# **Generic Environmental Impact Statement for License Renewal of Nuclear Plants**

## **Supplement 51**

### **Regarding Callaway Plant, Unit 1**

#### **Final Report**

**Figure 2–10. Surface Water Bodies in the Vicinity of the Callaway Plant**

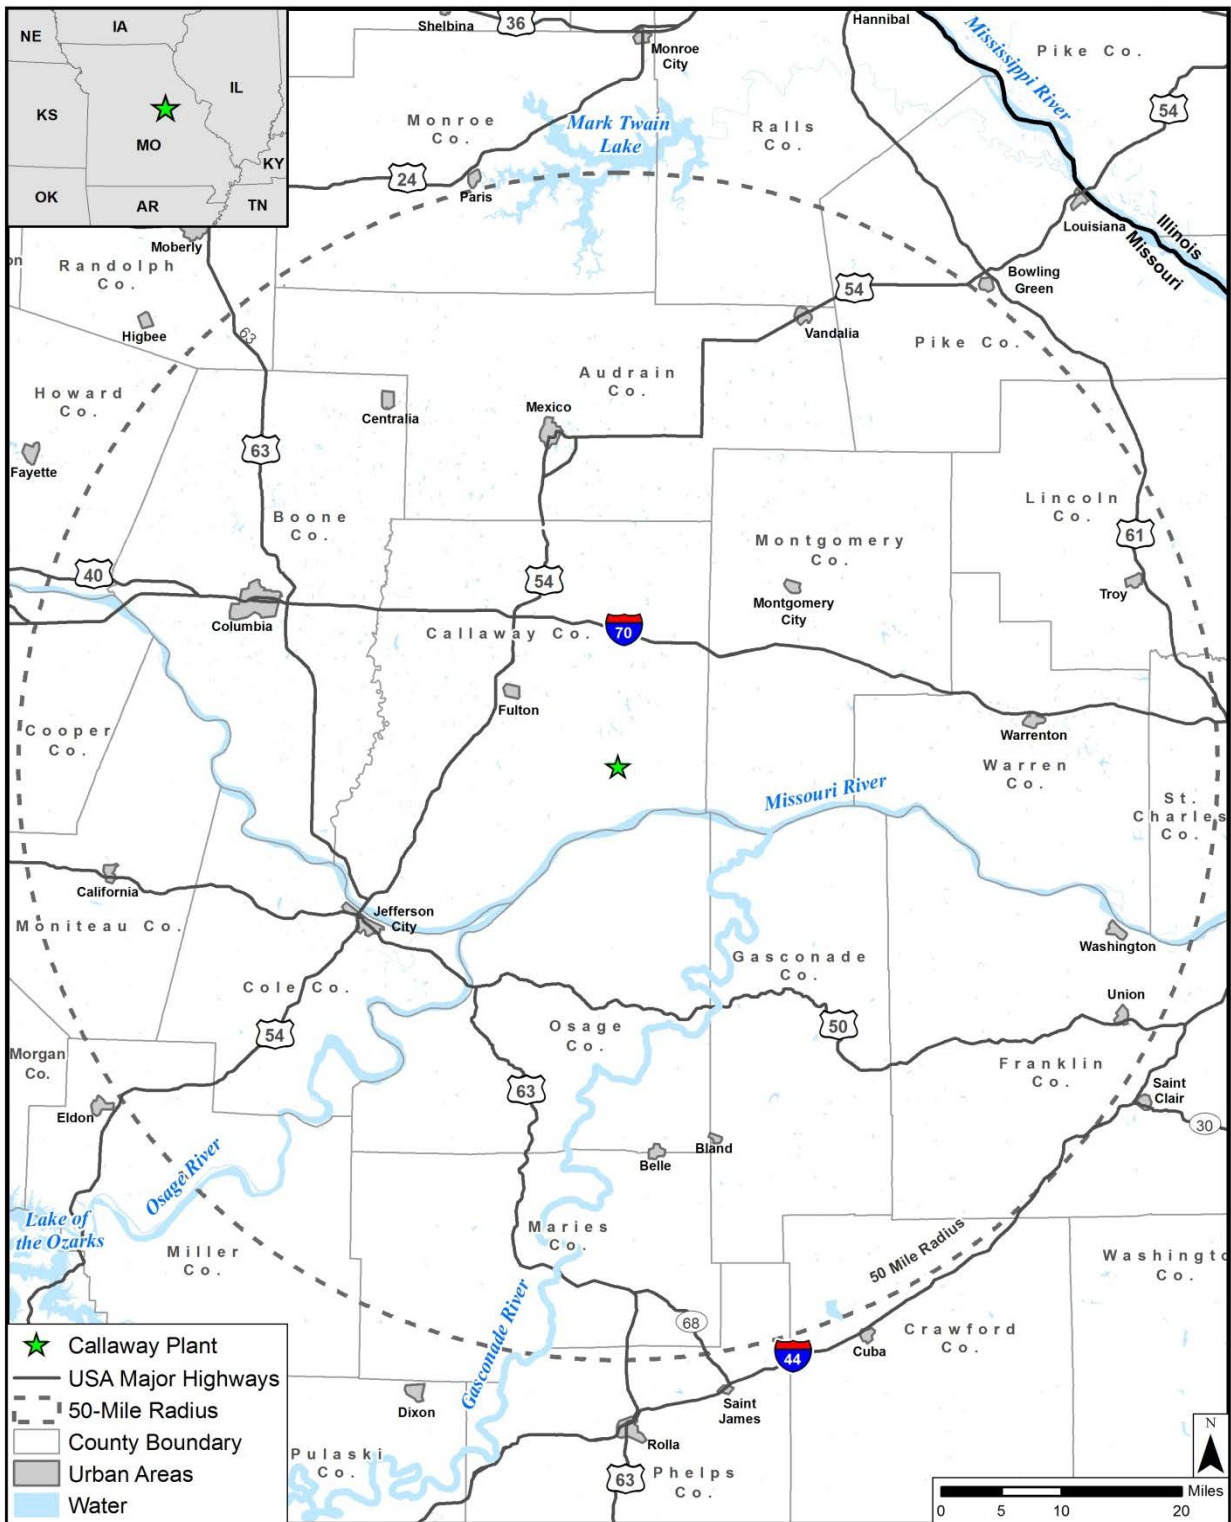
Section 2.2.4 Surface Water Resources, first paragraph, page 2-29. The first sentence of this paragraph states that ‘Callaway is located within the Missouri River Basin, Auxvasse Creek subwatershed, approximately 5 mi (8 km) northwest of the Missouri River (Figure 2–10) (Ameren 2011d).’ The paragraph goes on to state that a significant portion of surface water runoff from the site, perhaps the majority, flows to Mud and Logan Creeks, which is not within the Auxvasse Creek subwatershed as depicted on Figure 2–10, page 2-30. The first sentence of this paragraph and Figure 2–10 should be amended to include the Logan Creek subwatershed.

Section 2.2.4 Surface Water Resources, first paragraph, page 2-29: The first sentence of this paragraph states that "Callaway is located within the Missouri River Basin, Auxvasse Creek subwatershed, approximately 5 mi (8 km) northwest of the Missouri River (Figure 2-10) (Ameren 2011d)." The paragraph goes on to state that a significant portion of surface water runoff from the site, perhaps the majority, flows to Mud and Logan creeks, which is not within the Auxvasse Creek subwatershed as depicted on Figure 2-10, page 2-30. The first sentence of this paragraph and Figure 2.10 should be amended to include the Logan Creek subwatershed.

**Figure 2–11. Hydrogeologic Units Underlying the Callaway Plant**

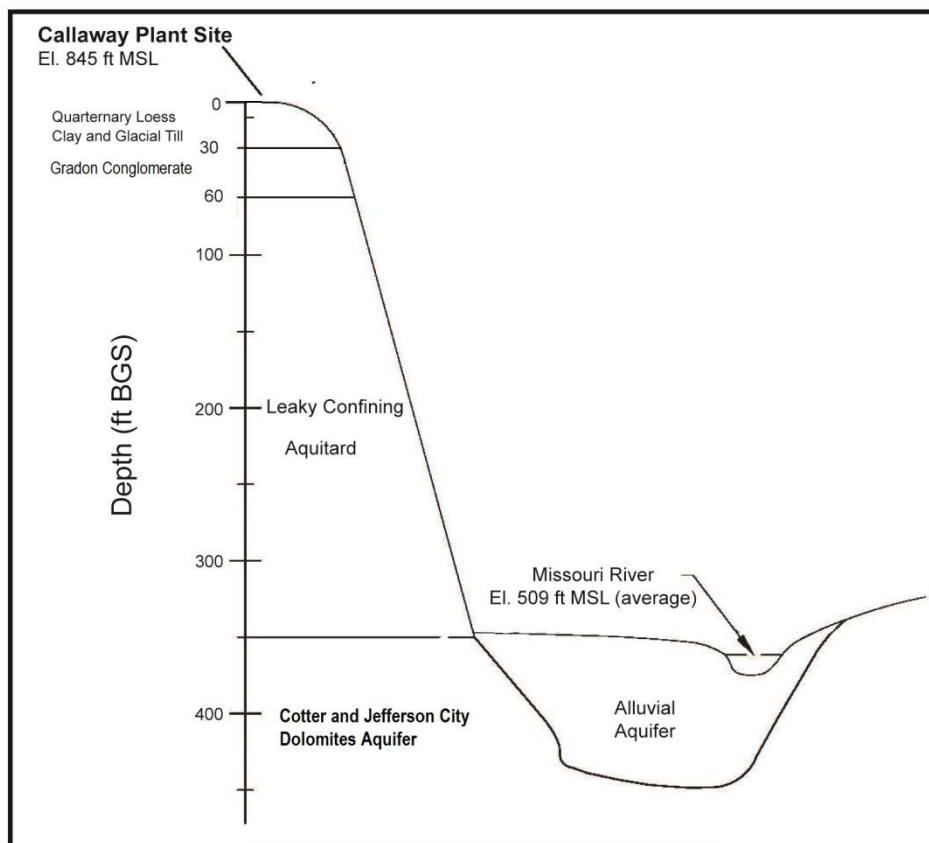
Section 2.2.3.1 Physiography and Geology, Figure 2–9. General Geologic Column, page 2-27: This illustration uses some geologic nomenclature that is out of date. The figure should be modified to reflect the current unit names. The ‘Graydon Chert Conglomerate’ is now known as the Graydon Conglomerate. The ‘Burlington Formation’ is properly the Burlington Limestone. The unit [labeled] ‘Bushberg Formation’ is [now] likely the Bushberg Sandstone. Recent geologic mapping by Starbuck (2008) identifies this sandstone as either the Devonian System Holts Summit Sandstone or the Mississippian Subsystem, Kinderhookian Series Bachelor Sandstone. The ‘Snyder Creek Formation’ is properly named the Snyder Creek Shale. The ‘Callaway Formation’ is now the Cedar Valley Limestone and the ‘Cotter/Jefferson City Formation’ is properly the Cotter and Jefferson City Dolomites (Thompson, 1995).

Section 2.2.5 Groundwater Resources, page 2-35 and Figure 2–12, page 2-36. Similar to comments in regard to Section 2.2.3.1 above, some of the nomenclature used in this section and in Figure 2–12 is not current. Further, the bedrock aquifer names, thicknesses, and delineations are incorrect and inconsistent with scientific literature. The authors of the draft SEIS are referred to Miller and Vandike (1997) and Gann et al. (1971) for a discussion of the hydrology in the northeastern area of Missouri. In addition, the portion of the aquifer that is described as confined in Figure 2–12 is unconfined in the area of the Callaway plant; it is partially drained by local streams and the Missouri River. In other areas of this groundwater province, the aquifer is confined.

Section 2.2.5 Groundwater Resources, page 2-35 and Figure 2-12, page 2-36: Similar to comments in regard to Section 2.2.3.1 above, some of the nomenclature used in this section and in Figure 2-12 is not current. Further, the bedrock aquifer names, thicknesses and delineations are incorrect and inconsistent with scientific literature. The authors of the draft SEIS are referred to Miller and Vandike (1997) and Gann et al. (1971) for a discussion of the hydrology in the northeastern area of Missouri. In addition, the portion of the aquifer that is described as confined in Figure 2-12 is unconfined in the area of the Callaway plant; it is partially drained by local

*The geohydrologic nomenclature (names of geologic units) in the draft SEIS was the nomenclature used in the license renewal submittal, an Environmental Report submittal for a new reactor at Callaway (application since withdrawn), and other cited documents. The nomenclature in the text has been changed to the presently accepted nomenclature. Former Figure 2–9 could not be updated for all of the units and has been removed from the document. However, Figure 2–11 was revised to better illustrate the known stratigraphy.*
